Exhibit 13C

Letter from Captain Mohsen El Missiry, dated 7/27/00,
Egyptian Delegation comments on
Group Chairman's Aircraft Performance Study Addendum 1

Please find attached herewith, the Egyptian Delegation comments to be included in the docket with reference to the "Group Chairman's Aircraft Performance Study Addendum #1" dated April 28, 2000.

OUTBOARD AILERONS ASSYMETRIC OPERATION ANALYSIS

Fig 1

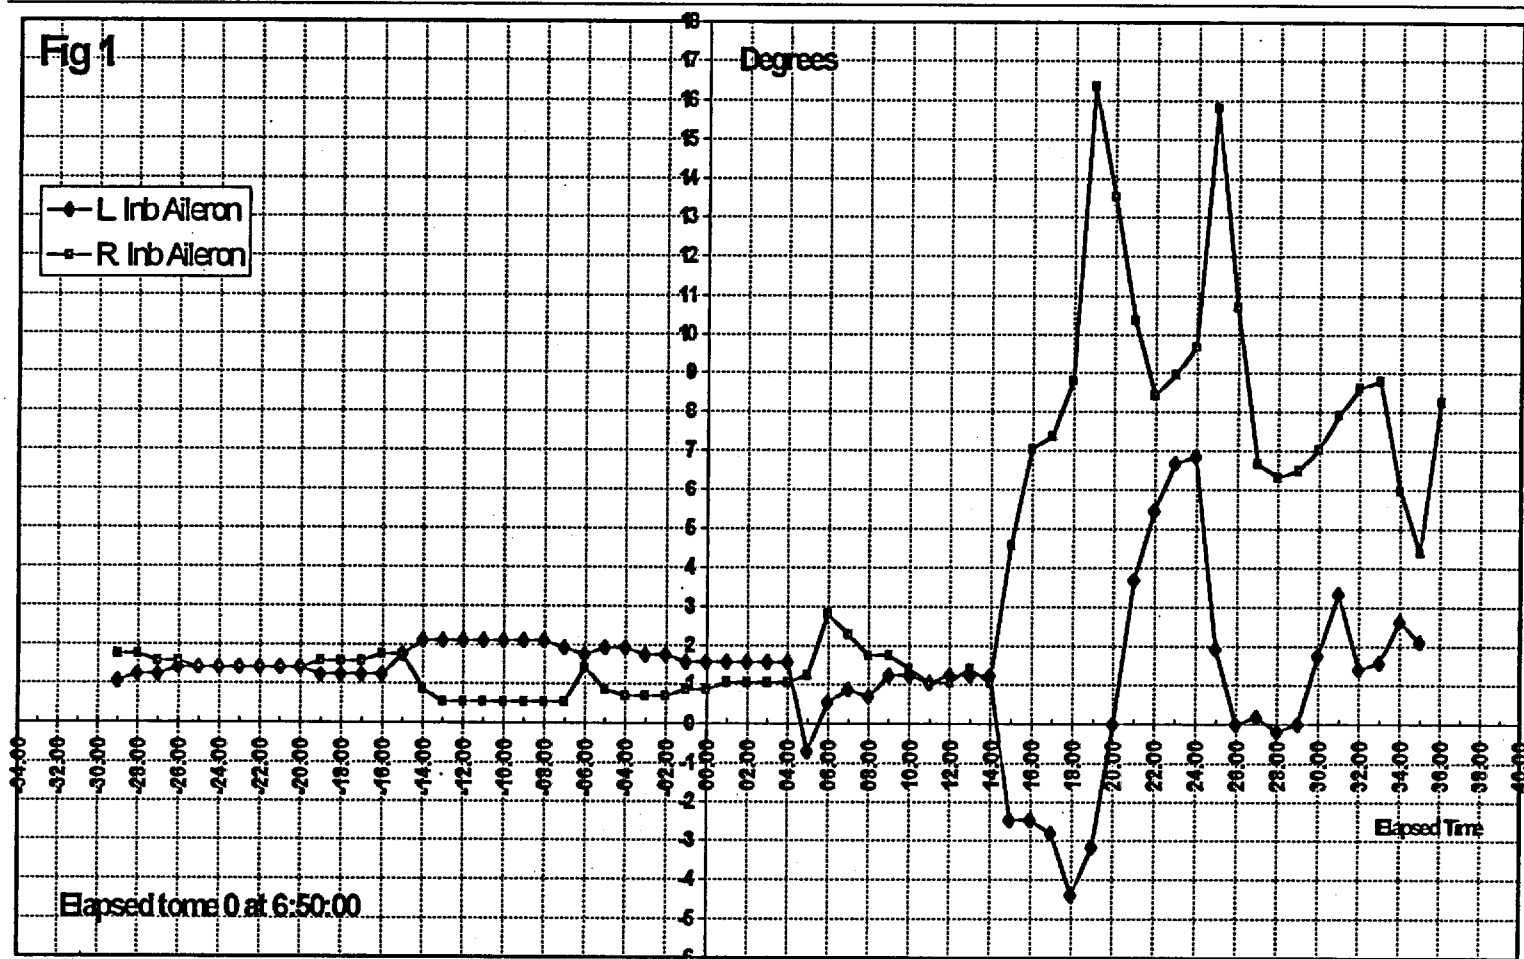
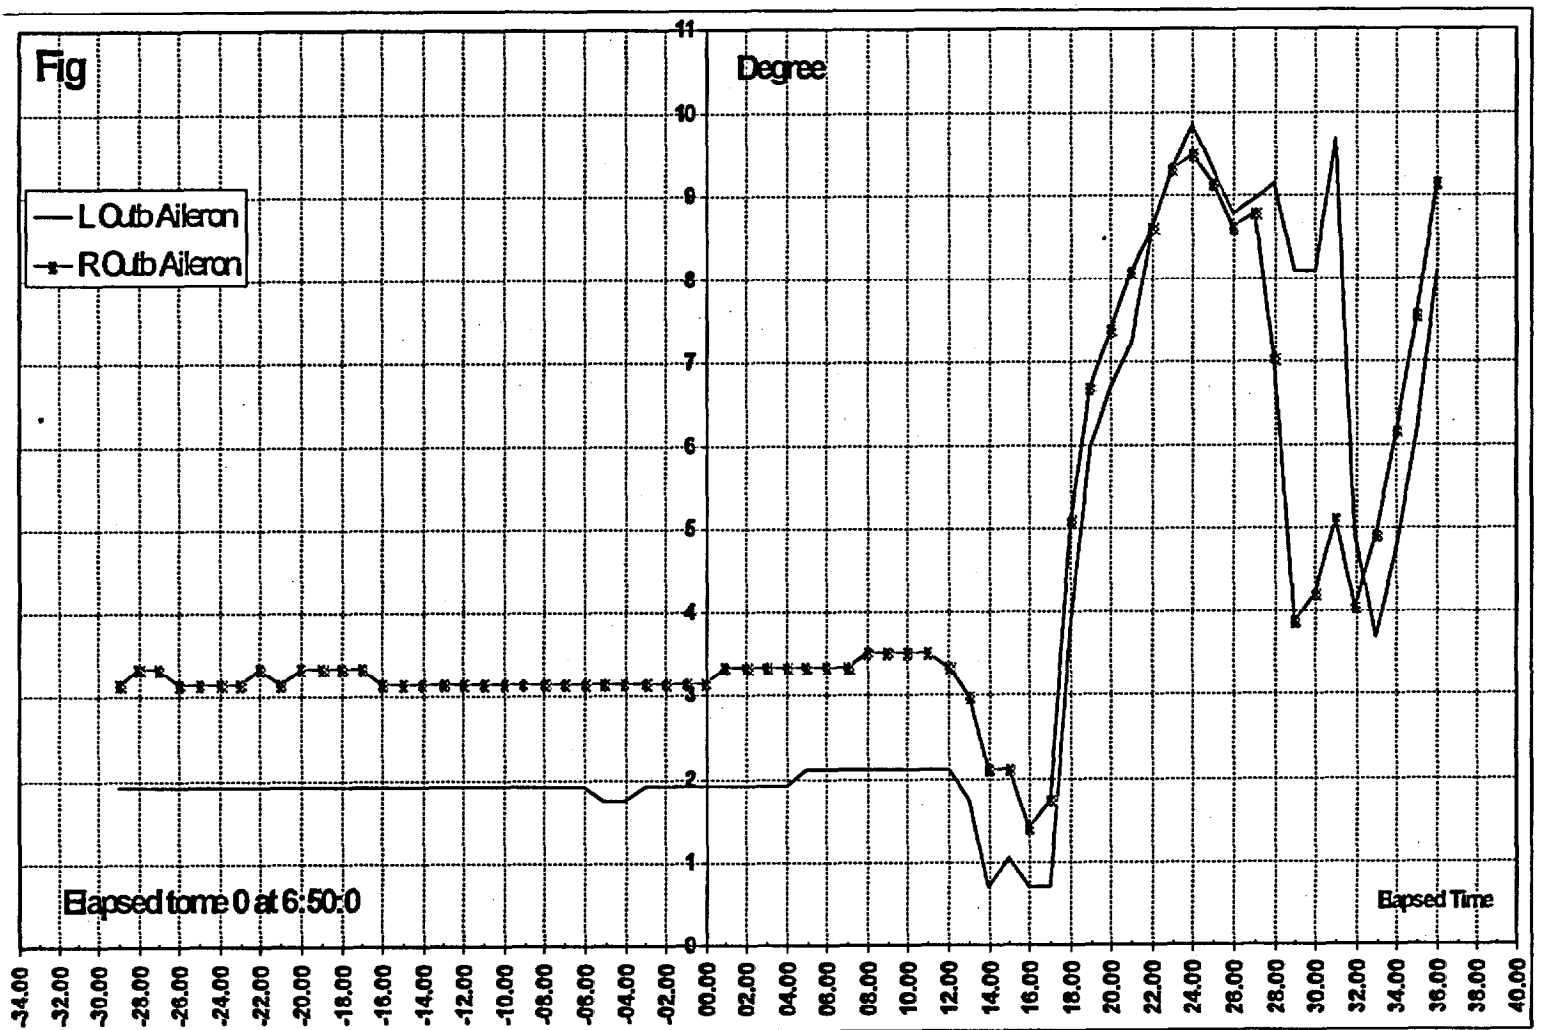
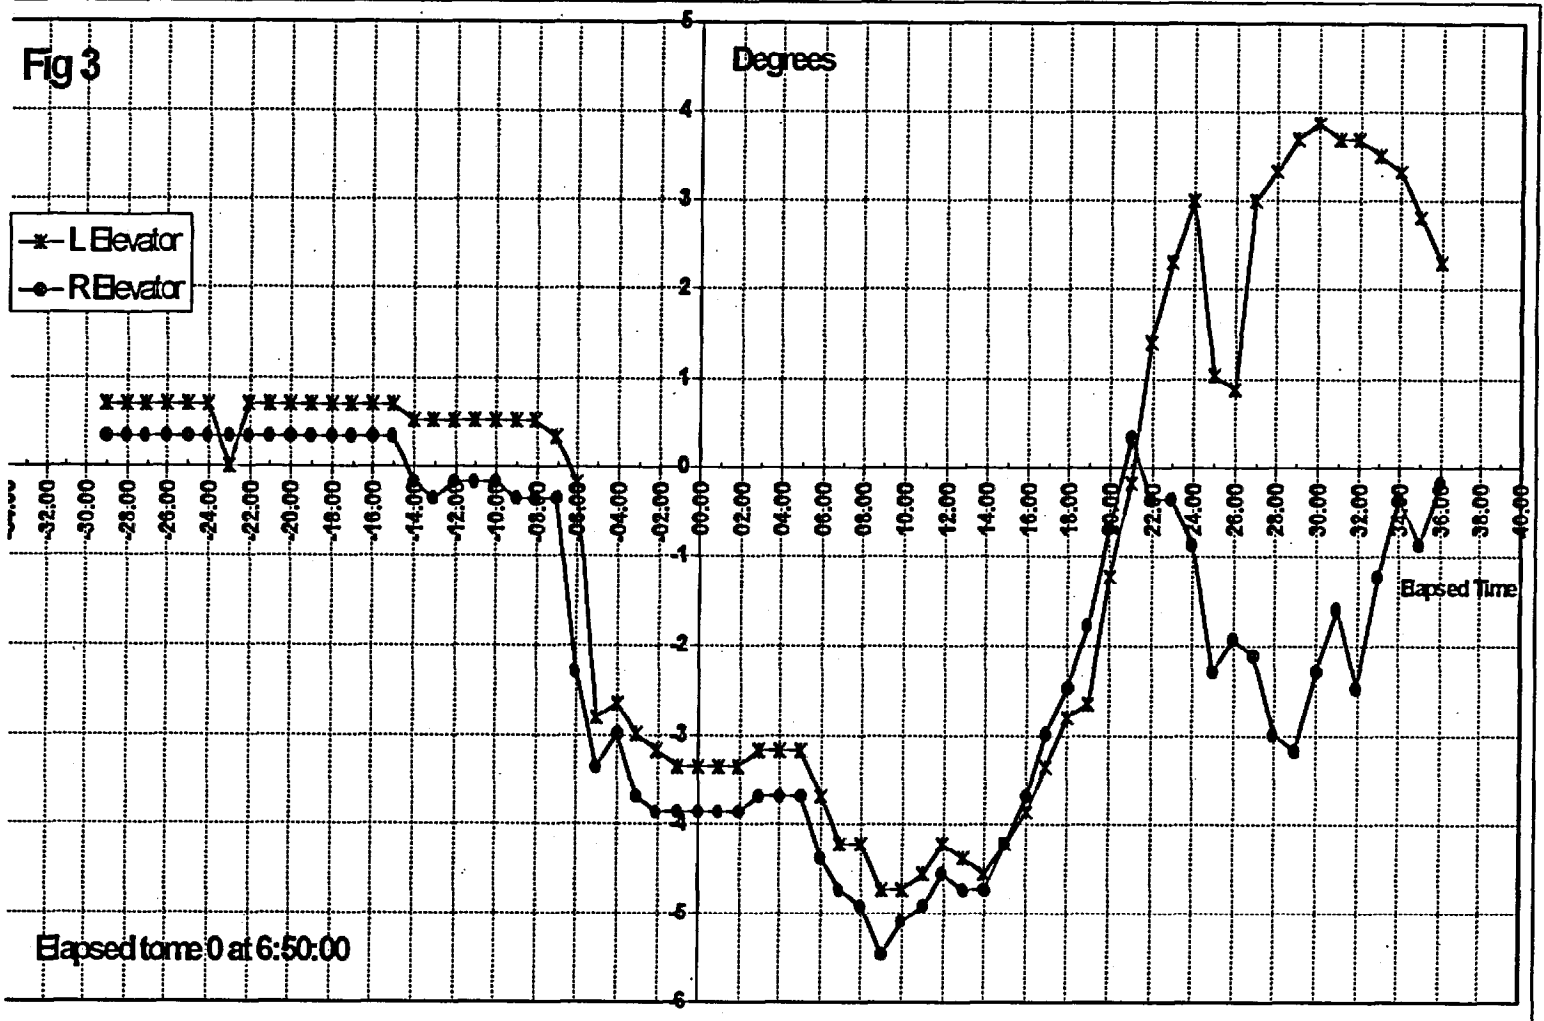
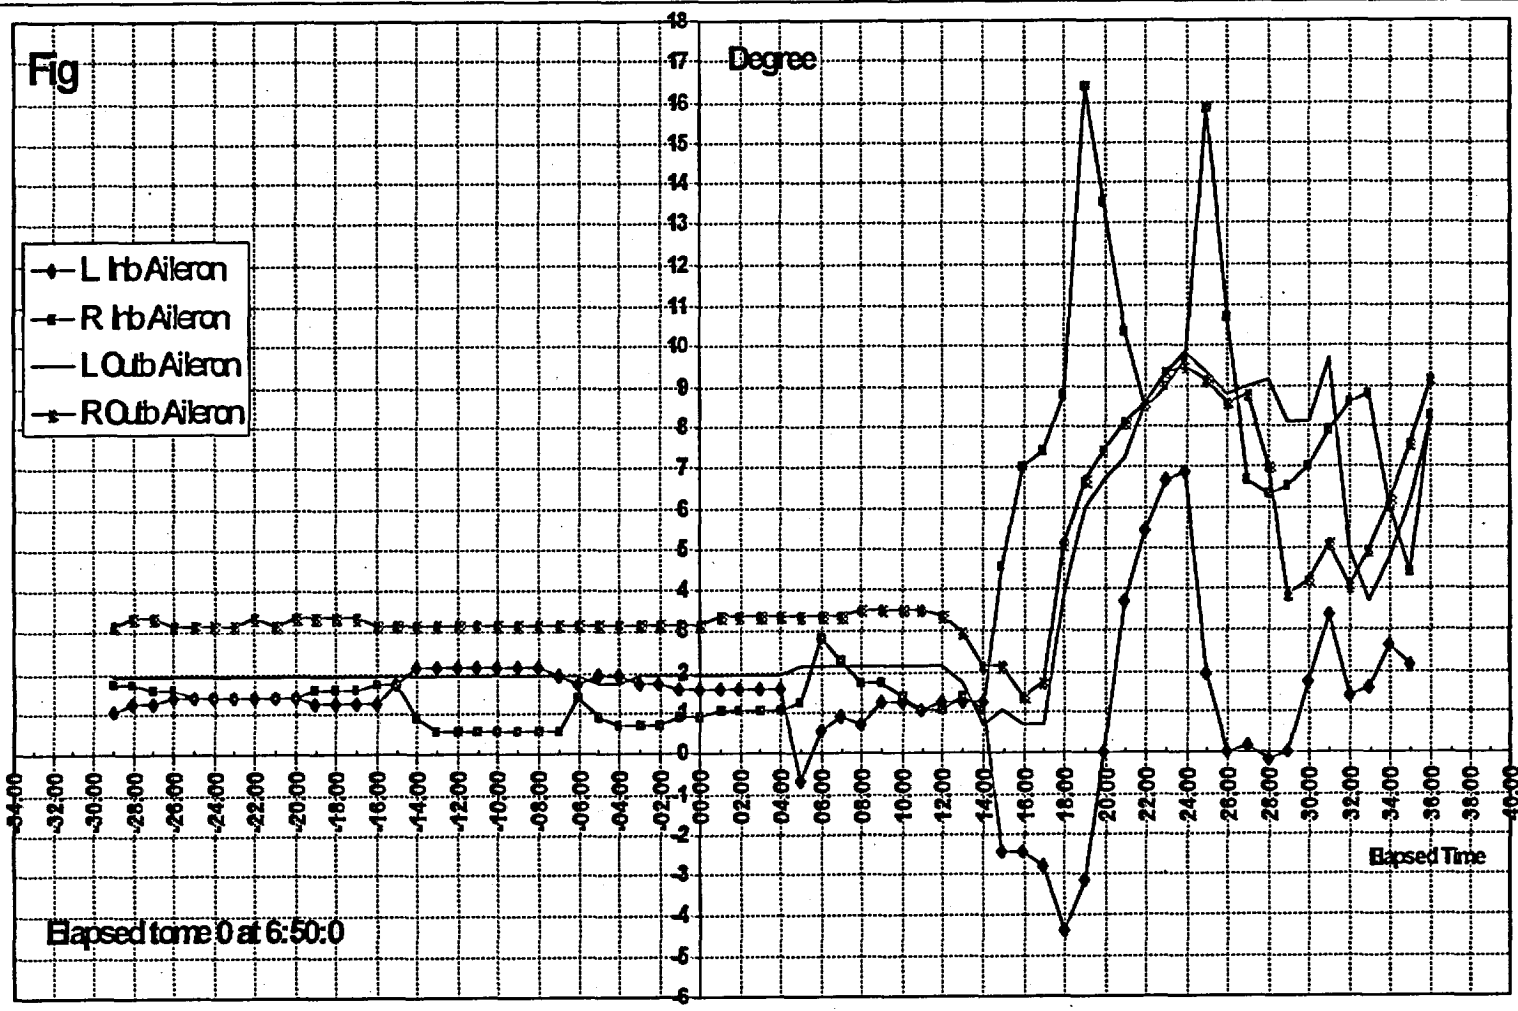
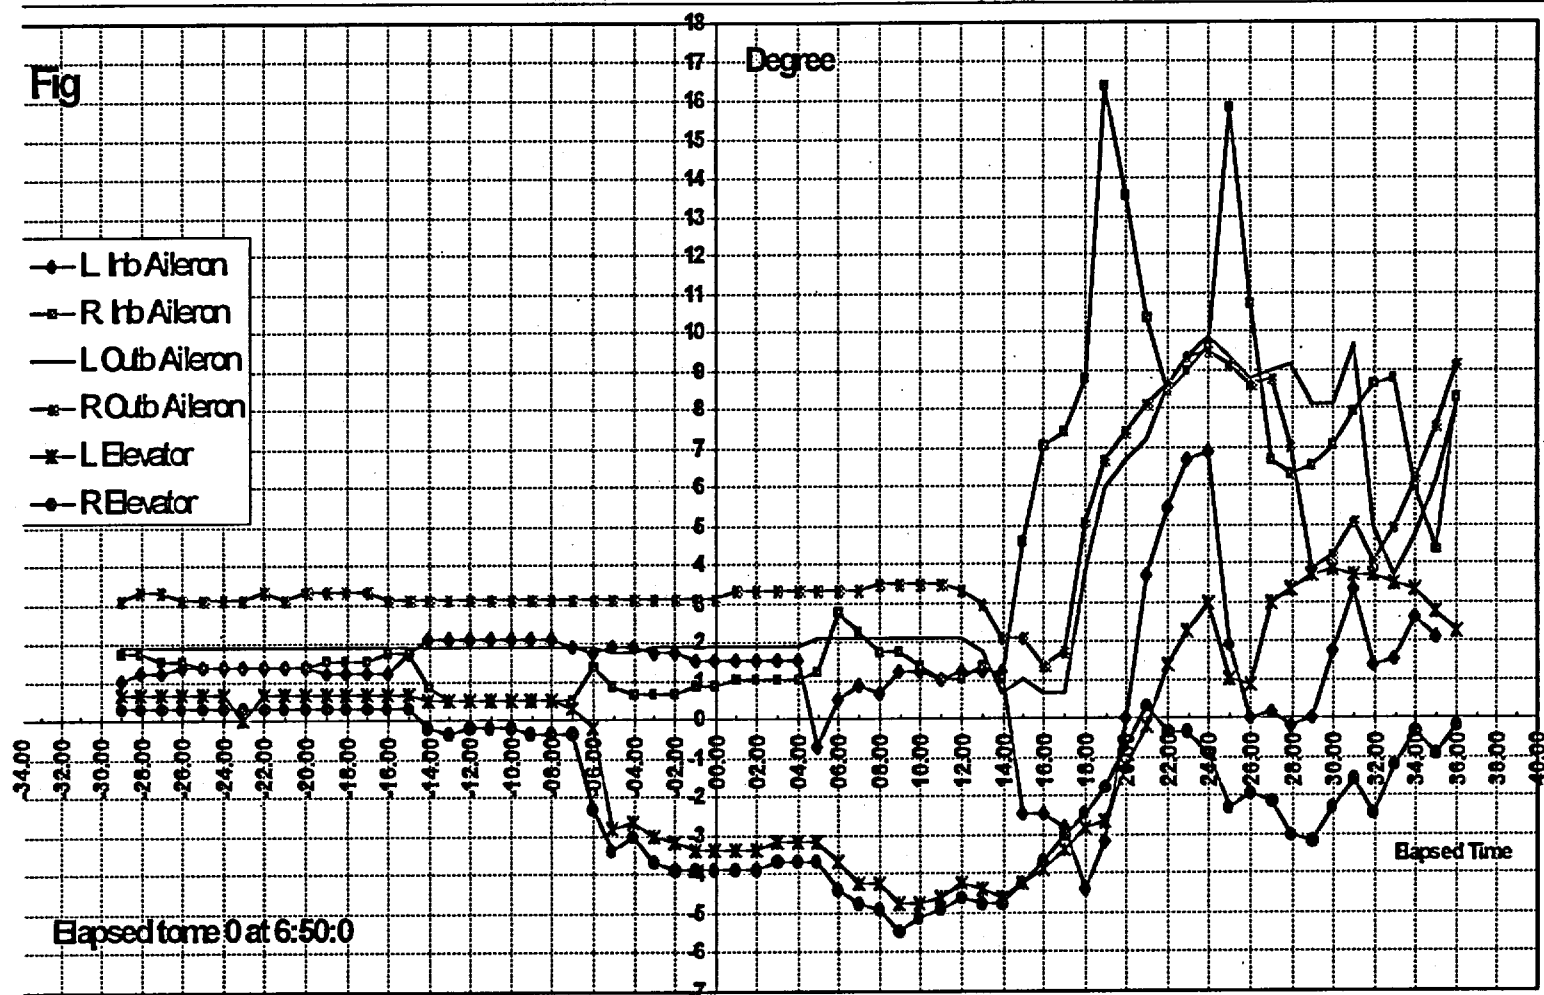
- Analysis of the FDR data showed non normal behavior of the inboard ailerons, outboard ailerons and elevators at the end of the airplane dive (figures 1 to 5)
